DYASONSKLIP SOLAR ENERGY FACILITY 1 (PTY) LTD.: APPLICATION TO AMEND ENVIRONMENTAL AUTHORISATION

Dyasonsklip Solar Energy Facility 1 (Pty) Ltd. now wishes to apply for an amendment to the EA to include a Battery Energy Storage System (BESS) within the authorised footprint, adjacent to the on-site sub-station. Full particulars on the intended BESS appears in their application.

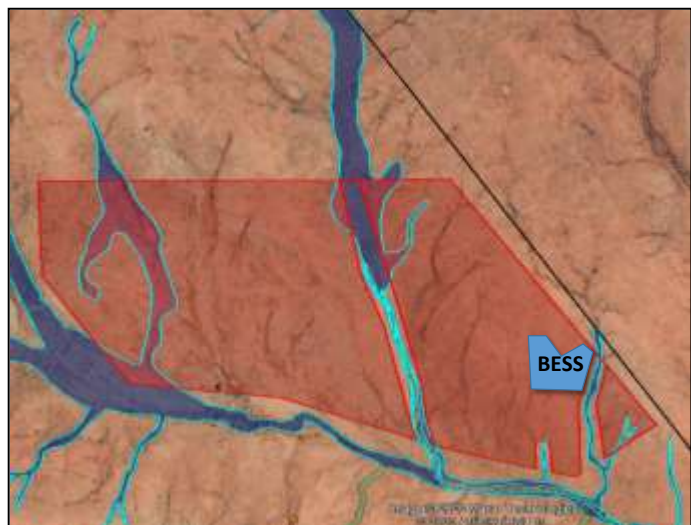
1. The BESS will indeed be placed within the authorised footprint and that no additional agricultural land will be involved or lost;
2. The construction of the BESS will have no additional influence on erosion or drainage patterns on site, since it will be located on higher local elevation with no defined drainage lines yet. The placement in relation to sensitive areas is shown in the figure on the right.
